Product Change Notice

Issue Date: 20th July 2026**Change Description:**

LED die change for Infrared SMT Round Lamp 850nm series.

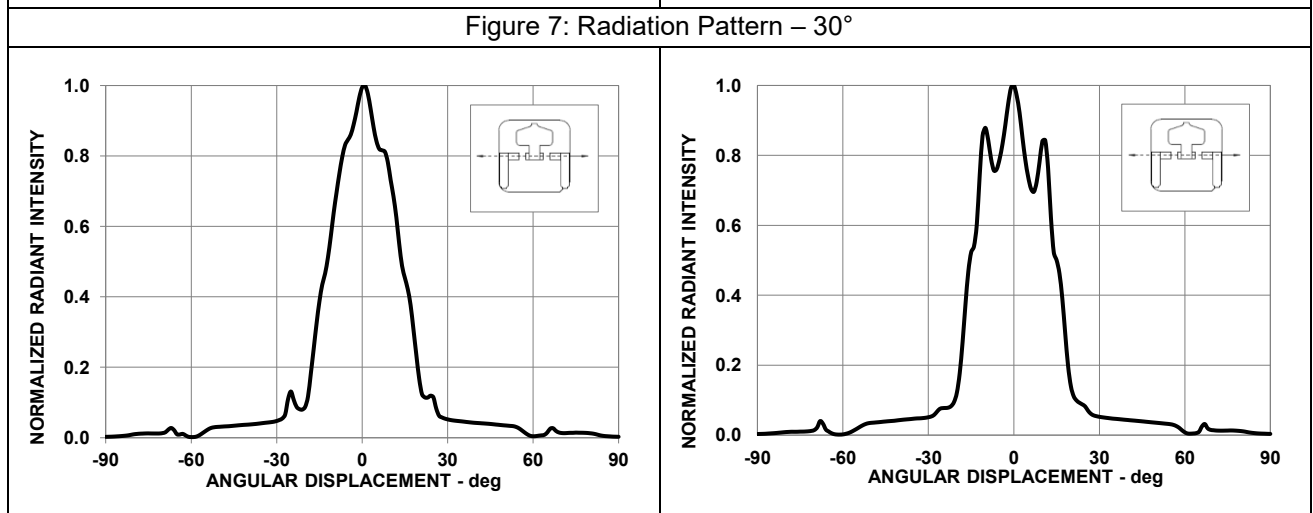
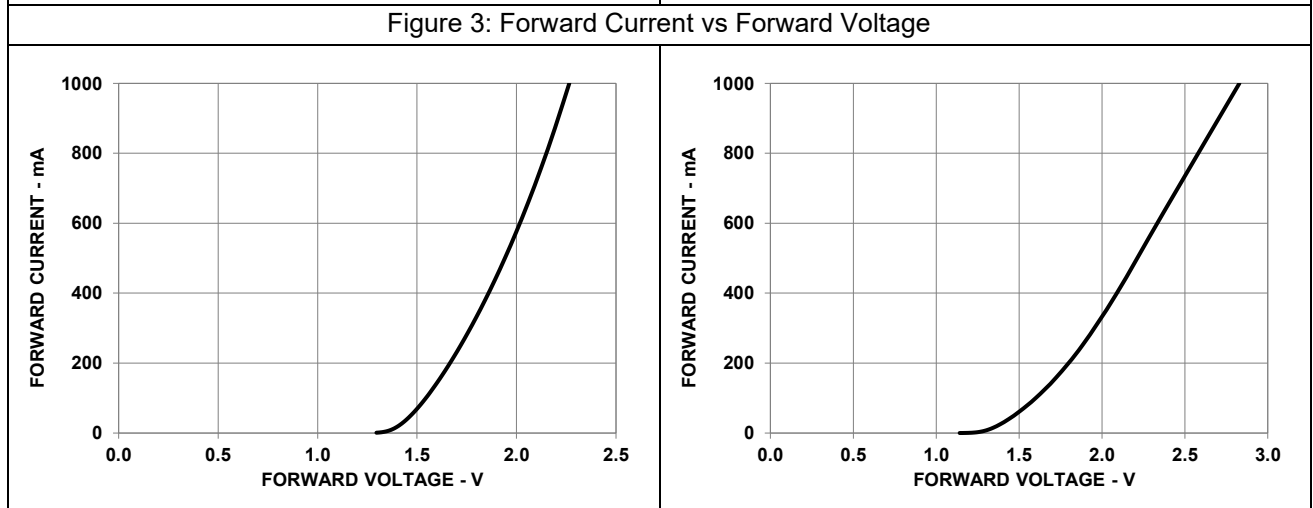
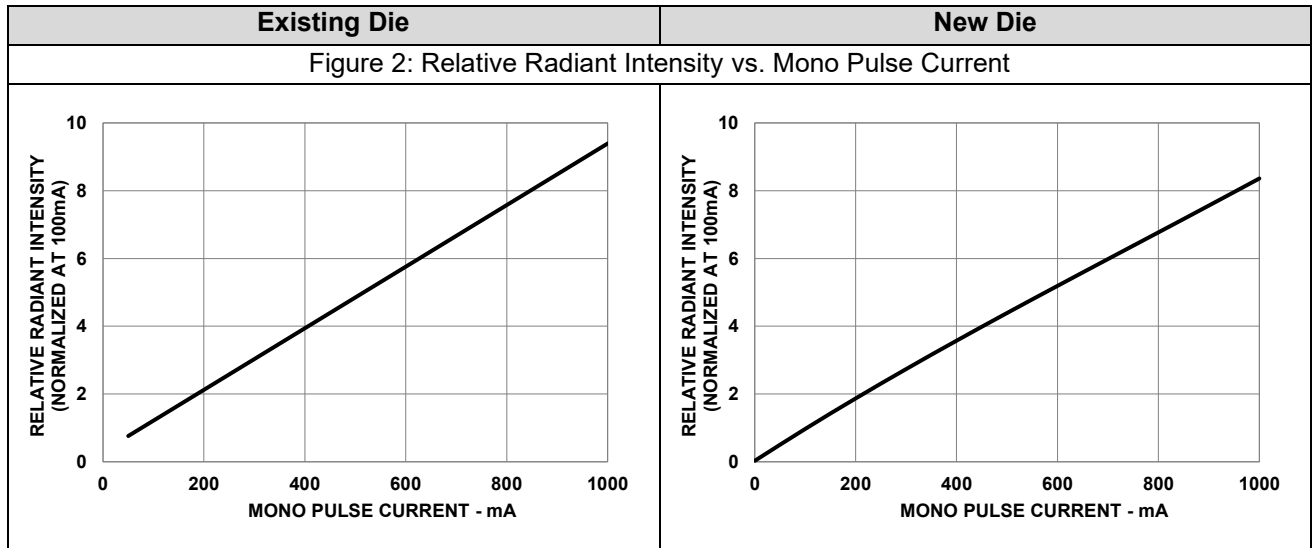
Introduce new LED die as current LED die supplier has ceased operation. The new replacement die is existing qualified dice for Broadcom.

No change in the product's fit, form, quality and reliability. There will be changes in the product's characteristics below.

Parameter	Symbol	Existing Die			New Die			Unit	Test Conditions
		Min.	Typ.	Max.	Min.	Typ.	Max.		
Forward Voltage	V_F	–	1.60	1.95	–	1.70	1.95	V	$I_F = 100 \text{ mA}$
